Meridian Firs Apartments

Deck Repair

2923 S. MERIDIAN ST., PUYALLUP, WA

1a A1.1

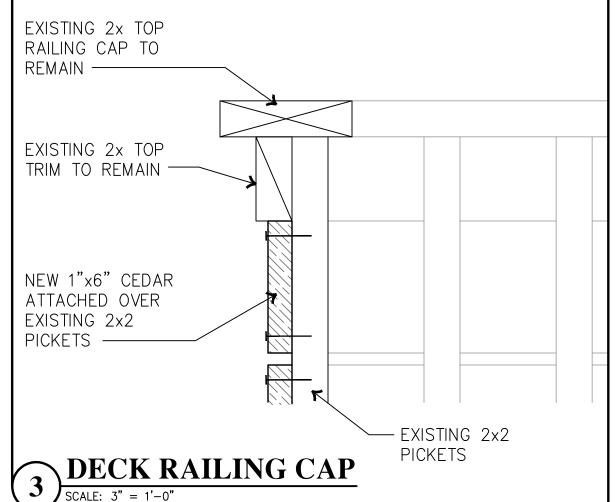
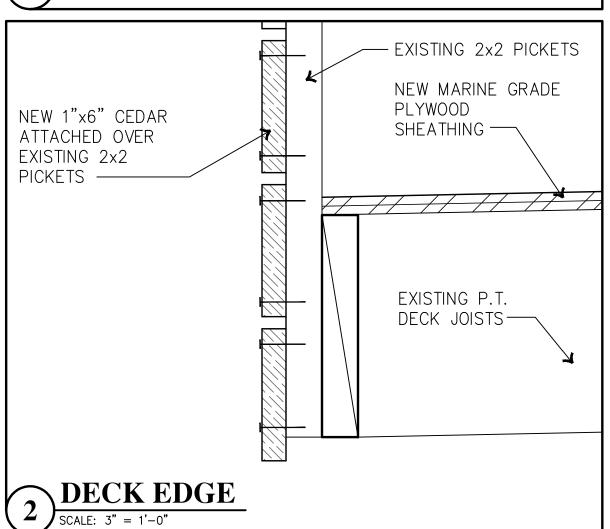
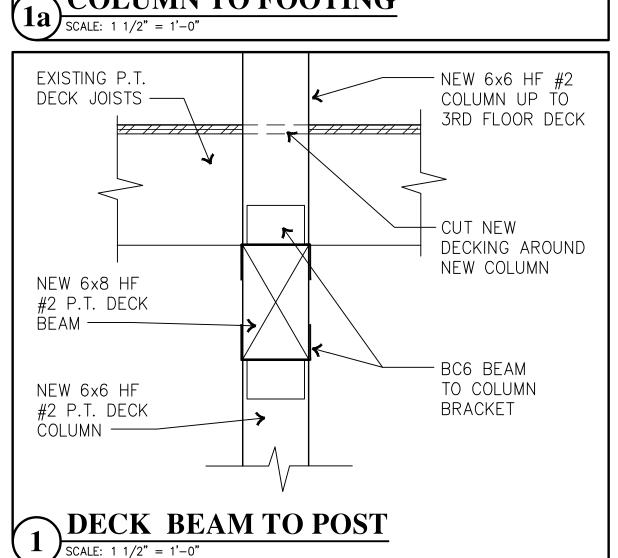
Detail the connection between the existing and proposed

(Construction Plans, Sheet A1.1, Detail 1a)

Updated all details and notes as needed to reflect the requested information.

Typical Deck Elevation - 3 Story SCALE: 1/4" = 1' - 0"

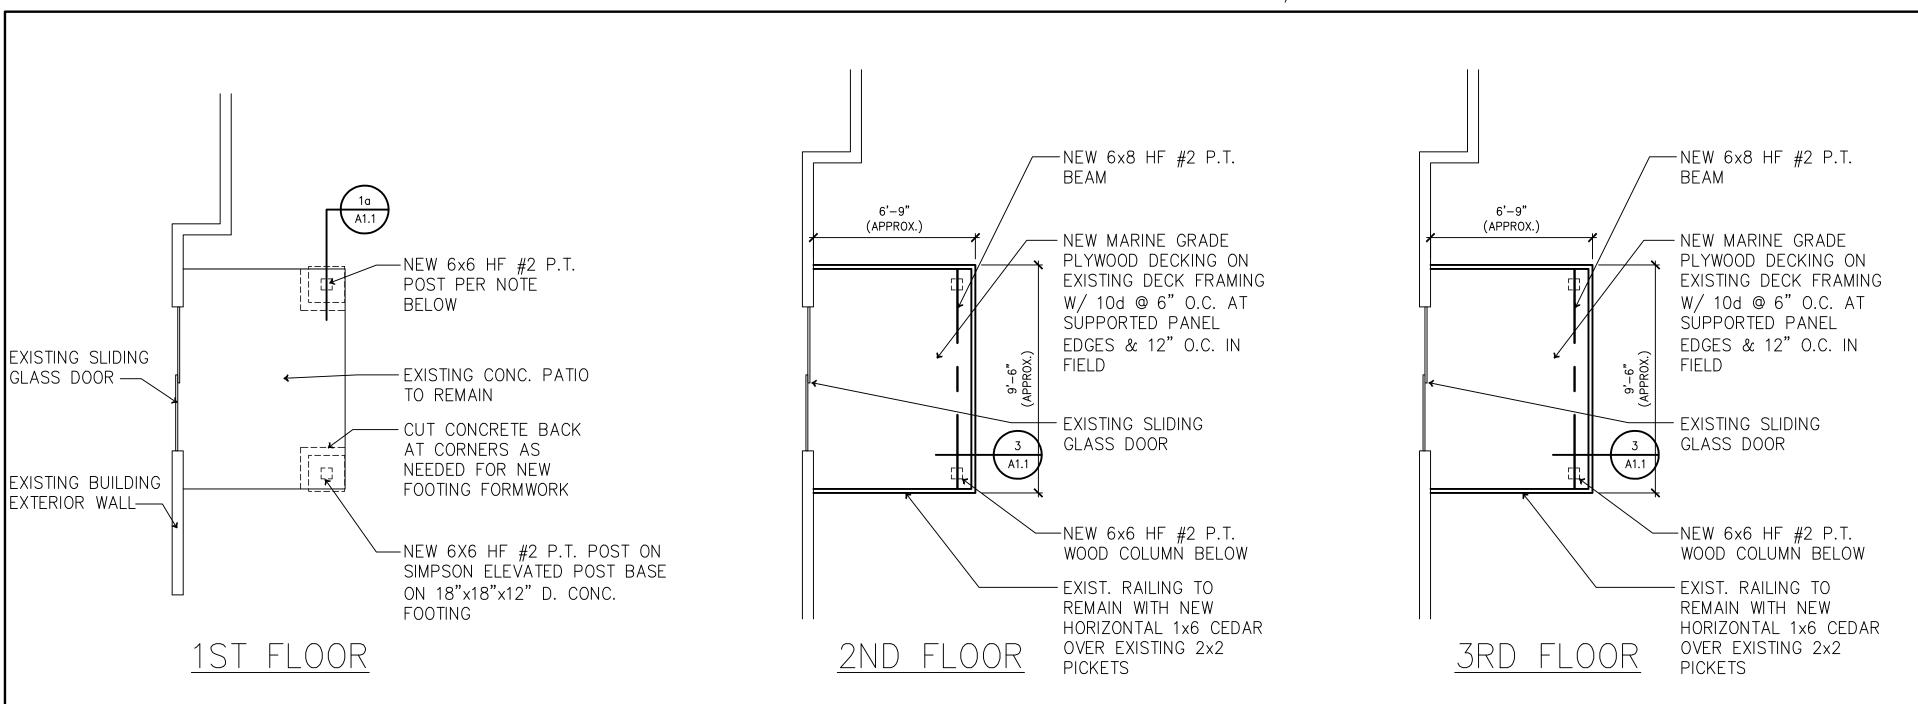
Add a notation on either Sheet A1.0 or A1.1 that contractor shall verify the integrity of balusters prior to the installation of the 1x6 cedar. Establish the parameters of the balusters replacement to include type, grade and nailing pattern.

(Construction Plans, Sheet A1.1)

Deck joists appear to be sloped to drain off of the cantilevered side of each deck based upon details 1 and 2. Detail 2 shows the installation of the 1x6 cedar board over the existing 2x2 balusters. detail or notate how the 1x6 cedar will be installed to prevent drainage and water accumulation on the deck surface.

(Construction Plans, Sheet A1.1)

Provide specifics of the plywood that will be installed which should include plywood thickness, grade and any other specifics that will reflect that the plywood will withstand the dead and live loads of the deck. Identify the non-slip surface that will either be provided on the plywood or will be added to the plywood as part of construction, as notated on sheet A1.0, Owner/Contractor Coordination Notes.

The existing joist spacing should also be considered when selecting the plywood material that will be used. Please provide the existing joist spacing.

(Construction Plans, Sheet A1.1)
